REF: JD 16/92

## ERRATA

**XJ6 93 MY (FROM VIN 667829)**

### BATTERY TRANSIT RELAY – REMOVAL

FIG 1

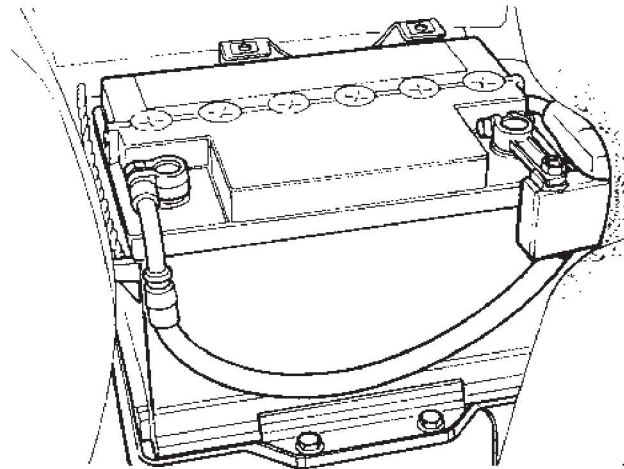
Owing to the relocation of the battery into the boot at 93 MY, a revised battery transit relay has been introduced, (see Fig 1).

The procedure for the removal of this new relay is as follows:

FIG 2

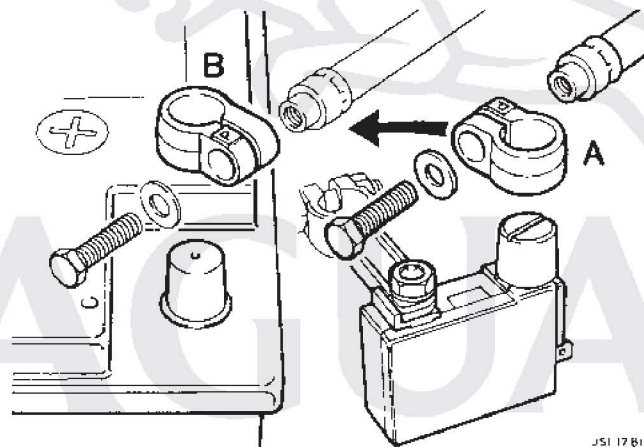
1. Open the boot and remove the battery cover, (see Fig 2).
2. Remove the negative lead from the battery.
3. Disconnect the transit relay from the battery.
4. Remove the white / yellow (W/Y) ignition wire from the transit relay.

FIG 3

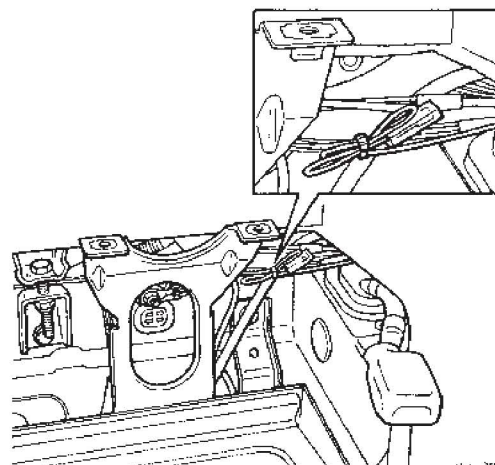
5. Remove the positive lead from the transit relay terminal post, (A, Fig 3).
6. Reverse the positive lead clamp and refit the clamp to the positive lead (B, Fig 3).

FIG 4

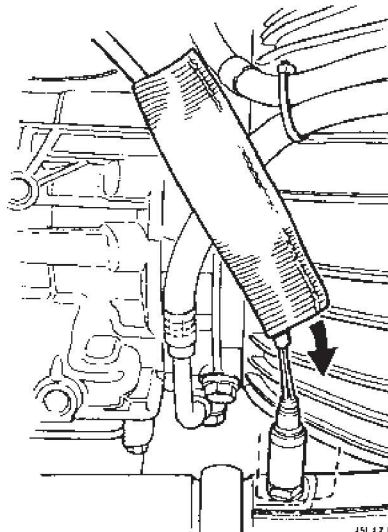
7. Displace the battery.
8. Tie back and secure the white / yellow (W/Y) ignition wire, (see Fig 4).
